UNITED STATES PATENT AND TRADEMARK OFFICE

APPLICATION NO.	FILING DATE	FIRST NAMED INVENTOR	ATTORNEY DOCKET NO.	CONFIRMATION NO.
10/581,832	06/05/2006	Matthieu Richard	3741	7186

Office Action Summary	Application No. 10/581,832	Applicant(s) RICHARD, MATTHIEU	
	Examiner FRANCIS M. LEGASSE JR	Art Unit 2878

DETAILED ACTION

Reproduced from US Patent No. 5,997,121

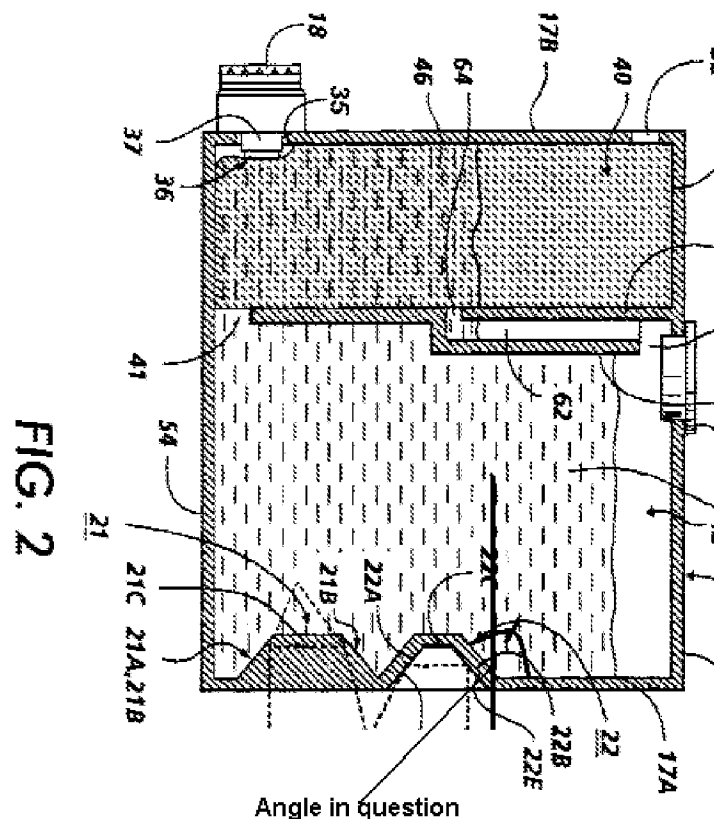
Applicant's arguments filed 7 June 2010, that the Altfather reference fails to teach a second angle with the surface larger than 75 degrees has been fully considered but is not persuasive. Examiner disagrees. It appears Applicant may have misinterpreted

figure 2 of the Altfather reference. In particular, element 22 forms an angle with surface (17A) which is clearly at an angle greater than 75 degrees (a figure has been supplied below). Please note the vertical axis. With respect to this particular axis an angle greater than 75 degrees is achieved by the second transparent elevation. Applicant must clarify the exact location for the measurement of this angle. Applicant provides no clarification thus the examiner's interpretation is well within the scope of the claim. Therefore, the rejections, as set forth are maintained.
